UNITED STATES DEPARTMENT OF COMMERCE
Patent and Trademark Office

09/176,580 10/21/98 SUNDARAM

Office Action Summary

DETAILED ACTION

Fig. 11

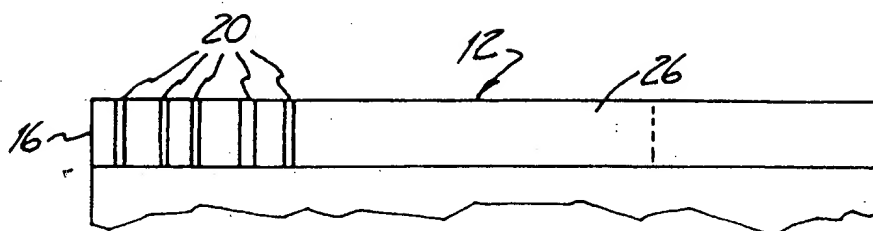
upon which sensor layers 18 are deposited (col. 3, lines 56-58). Since the rails are formed on the ABS (Fig. 2), inherently, it is expected that the ABS be configured prior to the deposition process. As shown in Fig. 1, the plane of the transducers is oriented along the ABS (not the trailing edge). (The numerals A-B have been added by the Examiner, see attachment to the Office Action).

Fig. 13

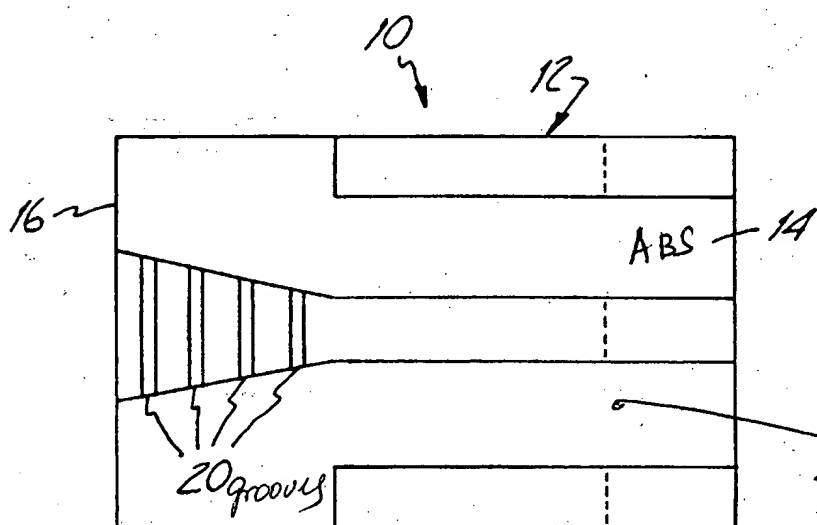
Boutaghou discloses in Figs. 1-4 and 13 a thermal asperity sensor comprising a slider body 12 having a leading edge A, transducers (magnetoresistive sensors/ MR) 18 spaced apart on rails (elevated bearing surface) 26 with grooves 20 (raised bearing surface) of an air bearing surface 14 ABS (col. 6, lines 6-7 and Fig. 1), a control circuitry for moving a head and lifting it above a disc surface (col. 1, lines 27-30). The leading edge is generally transverse (in this case perpendicular) to the ABS. The ABS also has a recessed surface B (Fig. 13). The transducers 18 are coupled to a peak circuitry 25 detecting a voltage spike indicative of a "thermal asperity" on a disc through bond pads (physical contact) or terminals (conductive strips) on a surface of the slider body 12 (col. 3, lines 36-38 and 56-58) and being capable to detect PZT excitation or other signals (col. 3, lines 43-45). The MR are fabricated by known technique from NiFe (col. 3, line 23) by deposition of very thin, as known in the art (col. 4, lines 8-9), layers, thus, constituting a very thin flat (planar) (col. 7, line 20) asperity contacting surface oriented along the ABS.
